FINAL PLAT OF
"HILLSIDE PARK"

RE: S/D 99-75 -- One-Step Final Plat of HILLSIDE PARK ADDITION

RE: S/D 99-75 -- One-Step Final Plat of HILLSIDE PARK ADDITION

CASE NUMBER: S/D 99-75 -- HILLSIDE PARK ADDITION

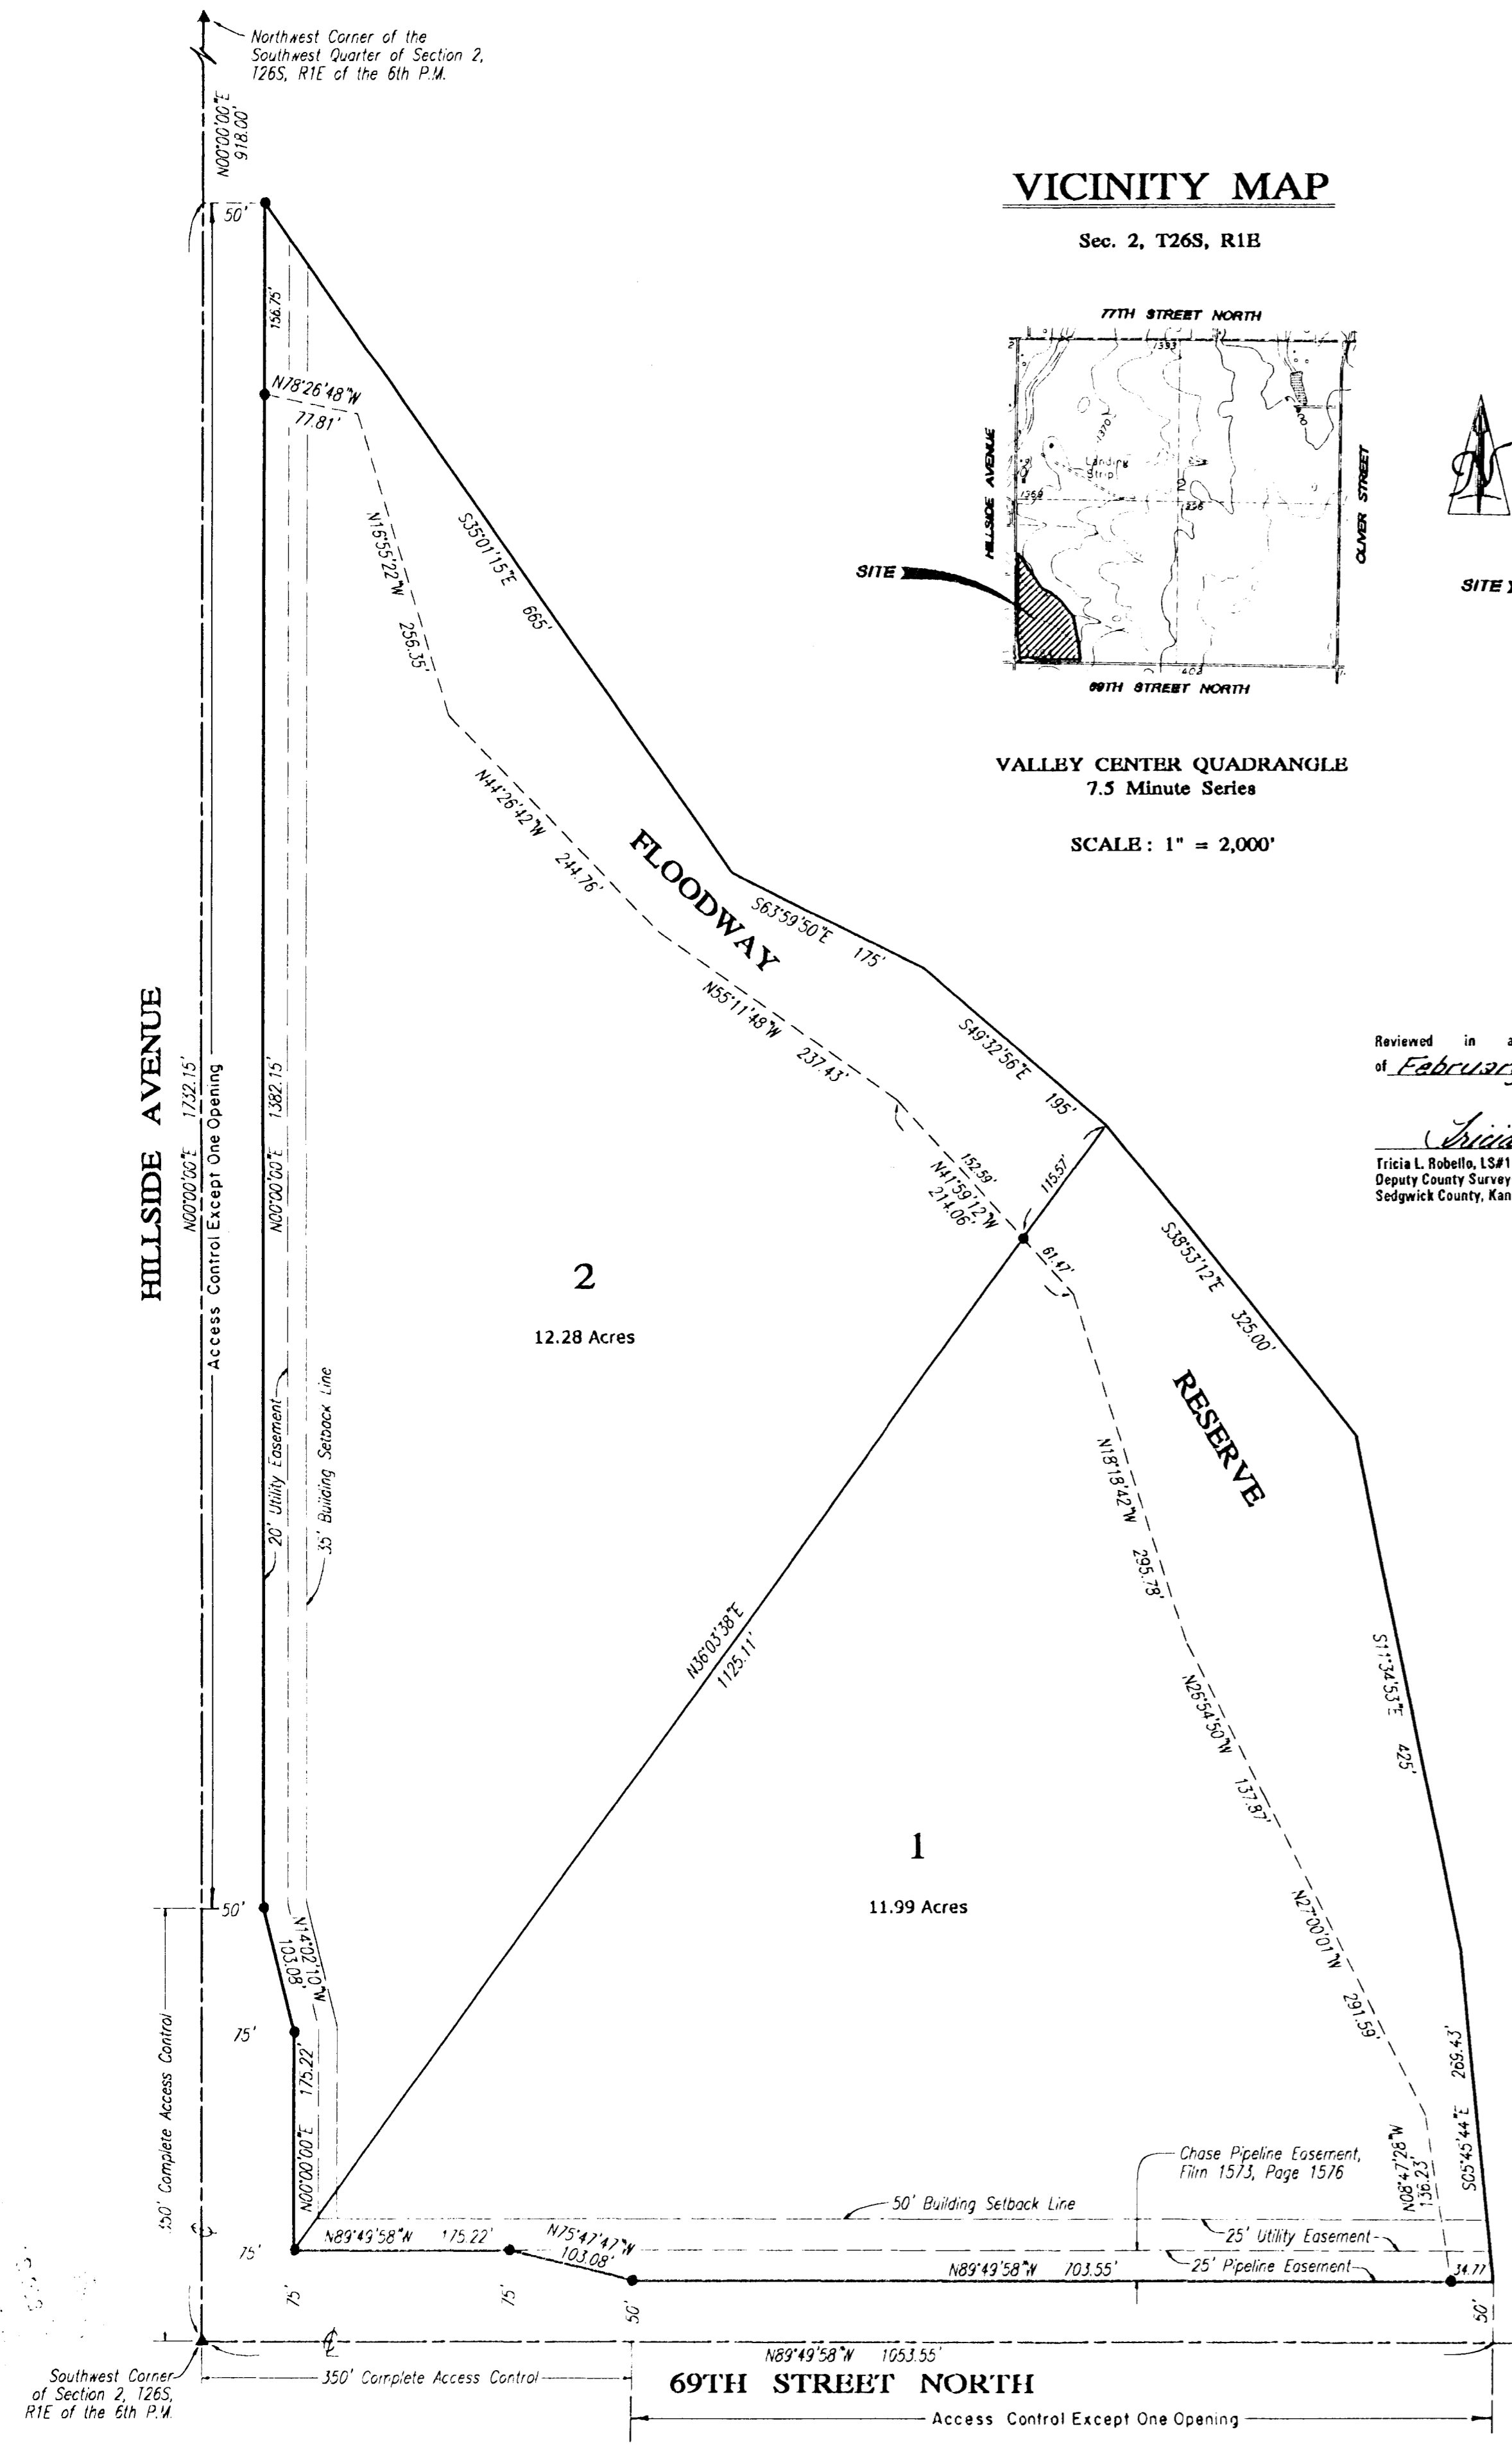
- C. County Engineering needs to comment on the status of the applicant's drainage plan. The drainage plan is approved.
- D. County Engineering needs to comment on the access controls. The face of the plat shall denote the access controls as referenced in the plat's text. The plat's text shall be revised to reference the "west" line of Lot 2. County Engineering has required 350 feet of complete access control from the section corner.

- E. The MAPC Chairman needs to be revised to reference "Francis S. Garofalo".

- I. The platting text shall include language that a drainage plan has been developed for the plat and that all drainage easements, rights-of-way, or reserves shall remain at established grades or as modified with the approval of the applicable City or County Engineer, and unobstructed to allow for the conveyance of stormwater.
